# Illustrated part list IPL update

**H560XP/XPG**

### Description of change

2. Clutch drum

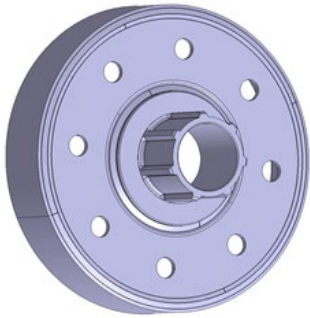
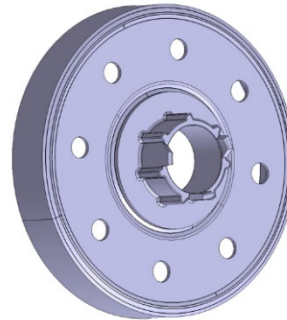
1. We have removed the label 535 05 80-01 on Clutch cover assy and added a moulded logo "Husqvarna". New colour: **Metallic Rough**.
2. New forged adapter has been implemented on the Clutch drum, the new Worm wheel has a new design due to this new adapter. The old Worm wheel 505 20 08-01 will **NOT** fit the new Clutch drum, and new Worm wheel will **NOT** fit the old Clutch drum.
3. New Oil pump 505 19 99-08 with increased diameter has been introduced to fit the new Clutch drum. New colour: **Natural**.

1. Clutch cover assy 501 84 61-01 is fully exchangeable. New colour: **Metallic Rough**.
2. Clutch drum and Worm wheel are **NOT** exchangeable.
3. Oil Pump is fully exchangeable. New colour: **Natural**.

Clutch drum assy kit 598 93 77-01/-02

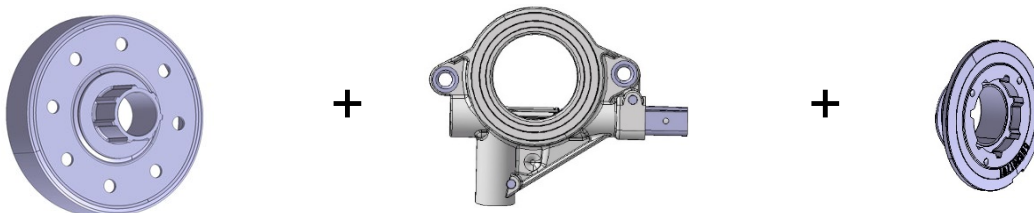
New Clutch drum assy Kit, 598 93 77-01/-02 is added. The Kit consist of: The new Clutch drum assy, new Oil pump and new Worm wheel.

Clutch drum assy kit 598 93 77-0-01/-02 is fully exchangeable.
